90-N-4 5, 8, 9 Pleasant Avenue

Peaks Island

BUILDING PERMIT REPORT

REASON FOR PERMIT: 15' x 10' deck

RE: TO BE SUBMITTED WITH APPLICATION TO MOVE SINGLE DWELLING 16'x20' FROM 90-N-8 TO (9-4-5(N)) SEPTIC SYSTEM LOCATION IN VIOLET INK.

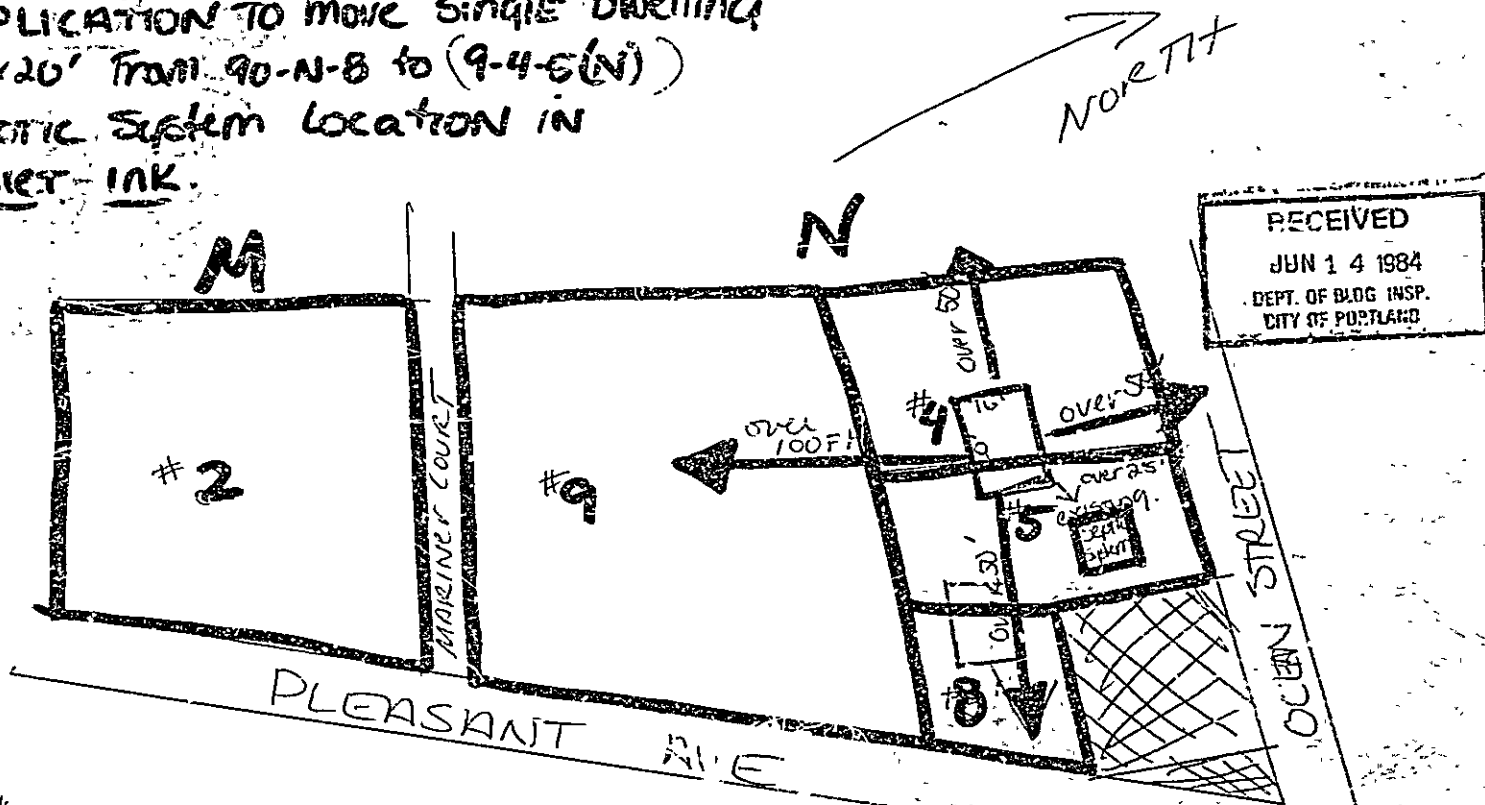
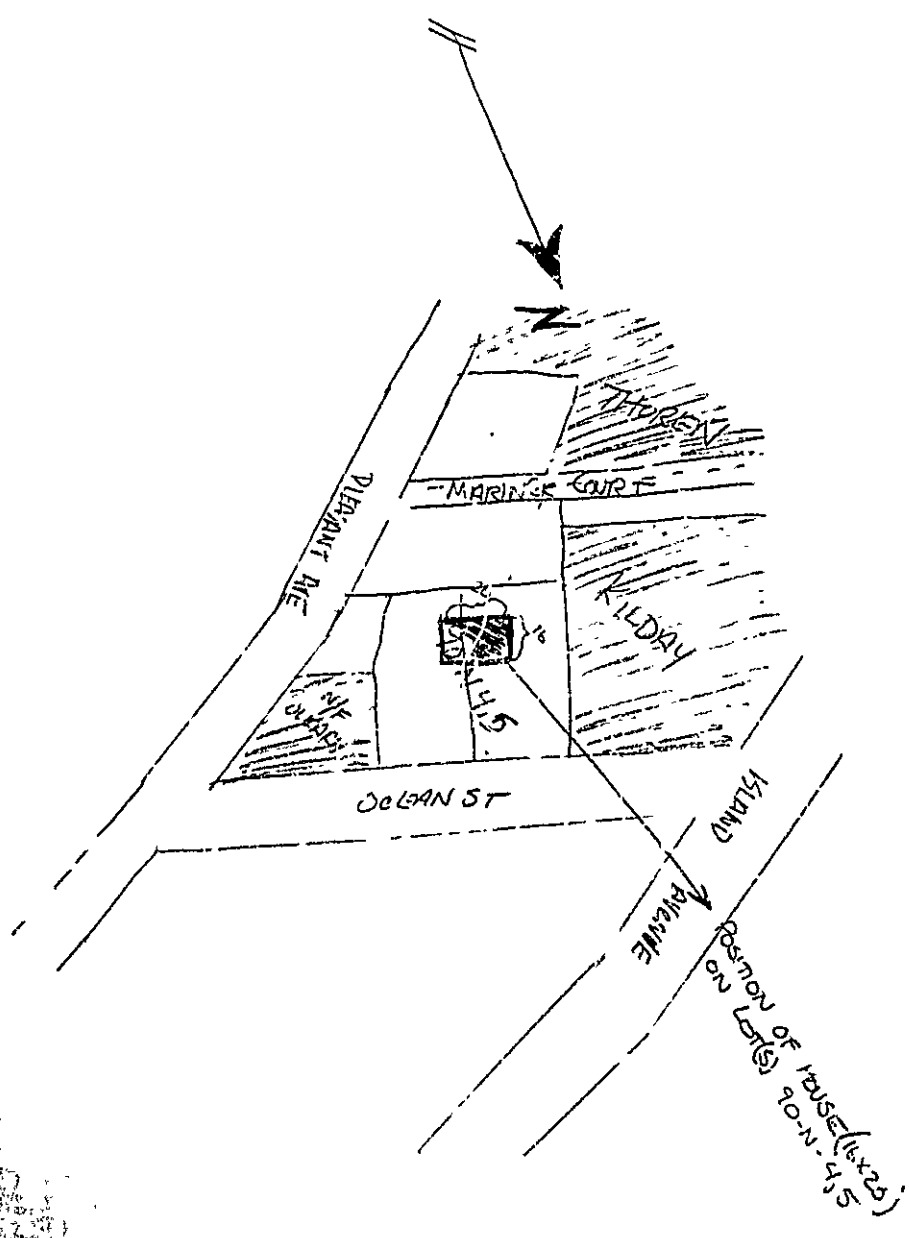
Your application to move a single family 16' X20' from 90-N-8 to 90-4-5(N) has been reviewed and your application didn't show what, nor where the septic system was located. Therefore, I cannot issue a building permit until this issue is solved.

* House Dimension 16'x20'

* existing Septic is located on lot # 5 and will be usable after House is moved. Septic is over 25' away from House

NO. 90-N-446

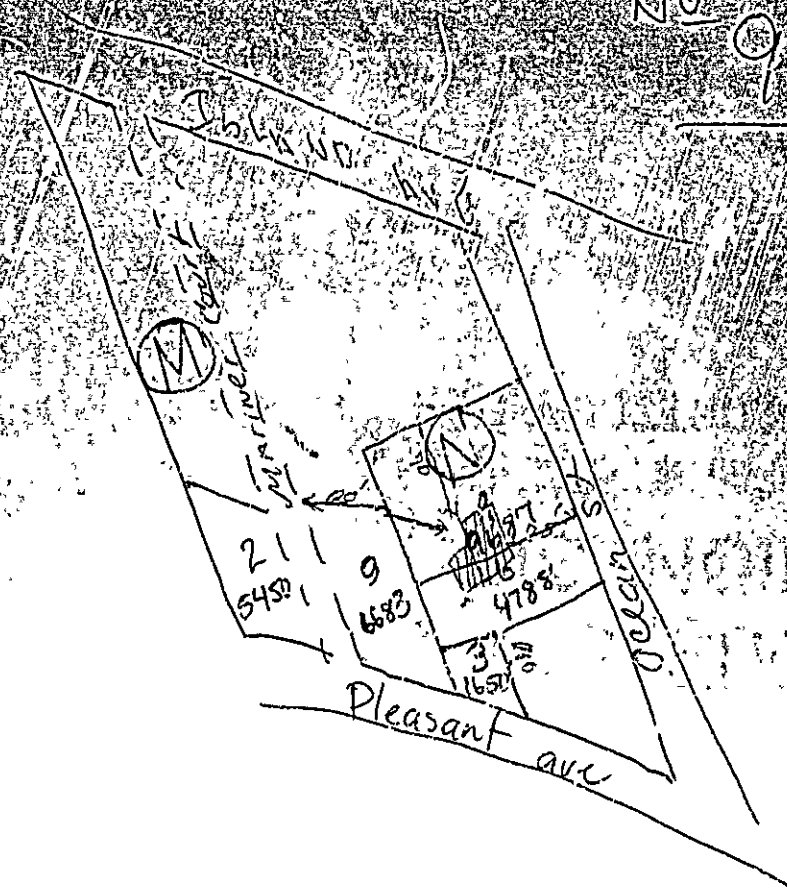
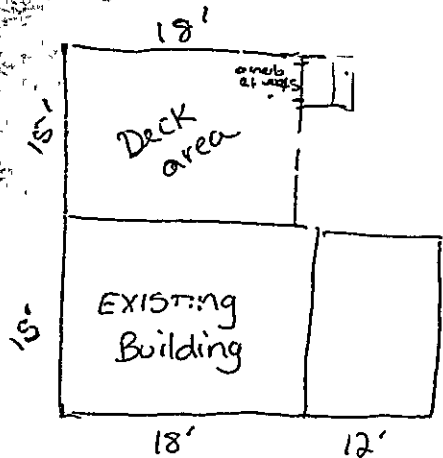
This is in reference to your application for a building permit for an open deck on the rear of your dwelling on Pleasant Avenue, Peaks Island, in the Island Residential 2 Zone. We can not ascertain from your sketch whether or not the proposed deck is in accordance with the setback requirements for the IR-2 Zone, which are as follows:

Front yard: 25 feet
Rear yard: 25 feet
Side yard: 20 feet
Side yard on Side Street: 20 feet

Please review your sketch and determine what setbacks are being provided from the outer edge of the deck to the front, side and/or rear of the building after the deck has been attached. We would appreciate having a revised plot plan to show that the proposed deck meets the above setback requirements. Please submit a revised plot plan to show that the proposed deck will meet these setbacks subject to review by the Code Enforcement Officer assigned to your district of the City.

Your application to construct an open deck 15'x18' has been reviewed and a permit is herewith issued subject to the following requirements:

- 1) Please read and implement item #7 of the attached building permit report.
- 2) Your plan shows 2"x 6" floor joists with a span of 15'. The building code would require a minimum of 2"x10", 16" O.C., for a 15' span. If the span is divided by a second carrying beam at 7 1/2', the 2"x 6" joists, 16" O.C. will work.

*Miss Johnson came
in and furnished
setback data
WJ Turner 5/31/88*
